Access Compliance Report Public Rights-of-Way (Pedestrian Signals)

Main Street: IRVINE_BLVD Cross Street: BROWNING_AVE Location: SW

ADA ID: SGRK211006112242 Signal Type: One Push Button-APS Overall Compliance: No Severity Scores: BTN 1: 25 BTN 2: N/A No BTN: N/A

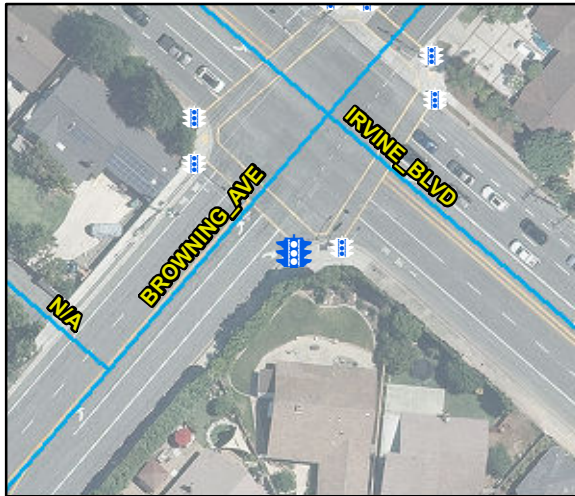
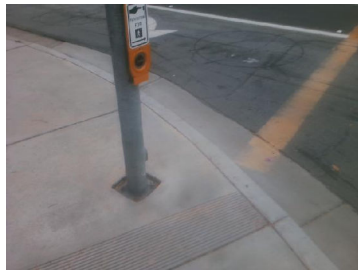
OC Std/PROW: R404.2

Possible Solutions: Remove and Replace Clear Space.
